Ref: EMS067

Client: A2Dominion Development Limited
Development: 156 West End Lane
Subject: Addendum to Energy Statement

RESPONSE TO COUNCIL'S COMMENTS

Figure A1 – January Design Day CHP, thermal storage and backup boiler output

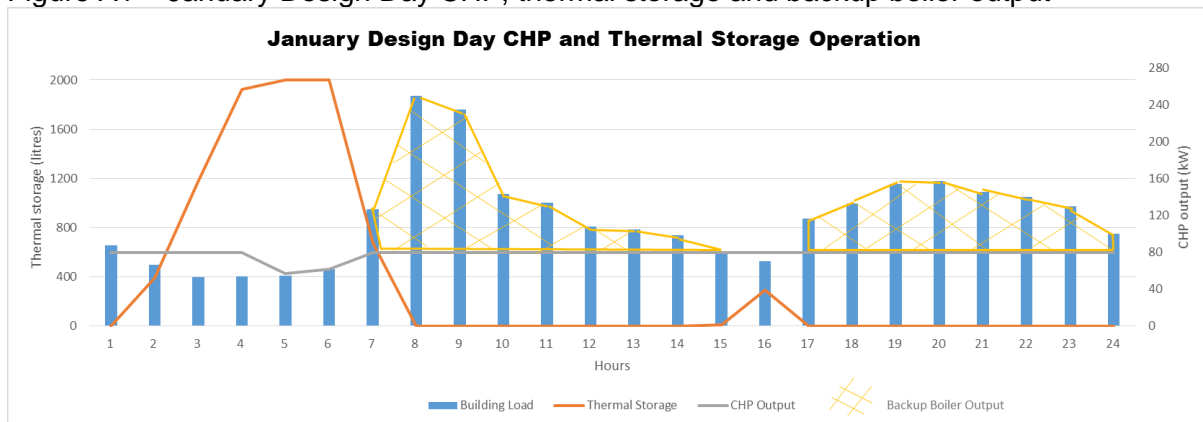
7.1 Please send through some commentary on heat and CHP profiles included in Appendix C to explain what is being modelled.

We would want the applicant to include measures on the graphs, include the backup boiler output on the graphs and also explain why there are big spikes in CHP output during June and September profiles. This is more of an Energy and Sustainability issue rather than AQ but would still need this information.

The information regarding the backup boiler output along with the explanation of the spikes during representative months is presented below.

Figure A1 depicts the operation of the CHP unit along with the thermal storage, the building load for a typical day in January. The grey line indicates the CHP output, the orange the thermal storage and the blue bar the building load/demand. As shown in the graph the CHP unit during the winter peak load will be working almost constantly producing 80 kW of power. For the late night hours (02:00 – 05:00 am) the demand from the development is lower than the CHP power capacity of 80 kW. Hence, the CHP unit will utilise this additional energy

production to heat the thermal storage tank up to its maximum capacity. When the building demand exceeds the CHP capacity (08:00 – 15:00 and 17:00 – 24:00) the backup boilers will fire up to provide the remaining required power (yellow area of below).
